Technical Bulletin

Subject: Reverse Gear, Will Not Engage or is Hard to Engage
Group: 34
Number: 03-01
**Model(s): S4 with 0A3 Transmission
(Trans. code FVD)**
**2004 >
(see VIN Below)**
Date: Nov. 20, 2003

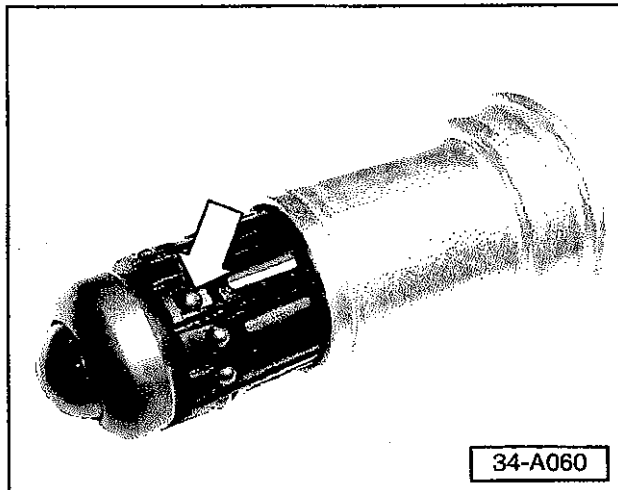
Reverse gear will not engage or is hard to engage.

- ◀ May be caused by a faulty selector cylinder locking bushing for reverse gear (cage for balls -arrow- jam in bushing or ball bearings have fallen out of the cage)

Optimized selector cylinder locking bushings beginning transmission number 13799 and transmission production date 07.10.03. (From VIN: 8E_4A112878).

Selector cylinder locking bushing for reverse gear, removing

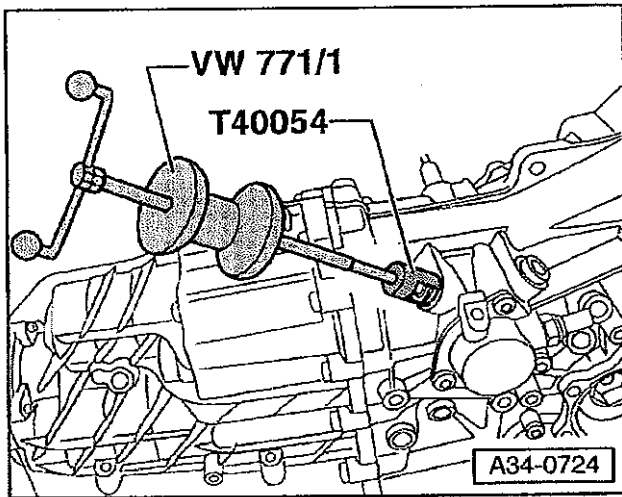
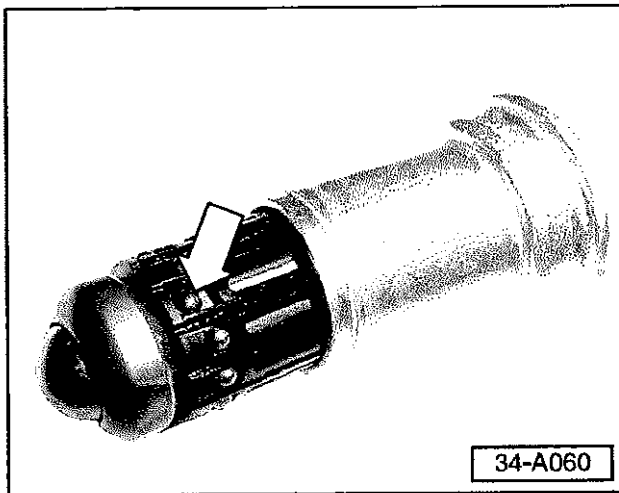
- Remove transmission (see Repair Manual Repair Group 34)
- ◀ - Carefully remove reverse gear selector cylinder locking bushing using special tool T40054 (for selector cylinder locking bushing above the selector shaft, T40050 can also be used) along with VW 771/1 (also see note).

So the locking bushing does not come apart, special care should be taken (light taps with the slide hammer weight) when the end of the locking bushing nears the end of the housing.

Selector cylinder locking bushing, checking

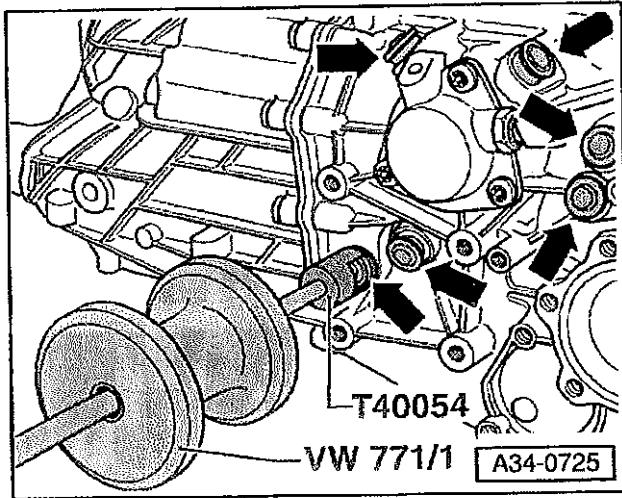
- ◀ - Check whether any of the ball bearings (arrow) have fallen out of a damaged selector cylinder locking bushing and into the transmission.

If this is the case:

- Replace the transmission.

Selector cylinder locking bushing, installing

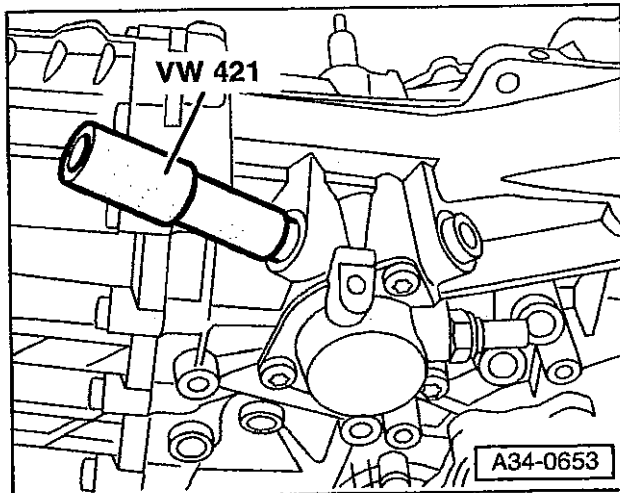
- ◆ The reverse gear selector cylinder locking bushing is most likely the cause.

To prevent this condition from occurring on reverse gear or another gear at a later date:

- ◆ All 6 selector cylinder locking bushings (arrows) must be replaced.

- ◆ Install 6 cylinder locking bushings Part No: 0A2 301 242A using special tool VW 421.
- Tap bushing in until fully seated.
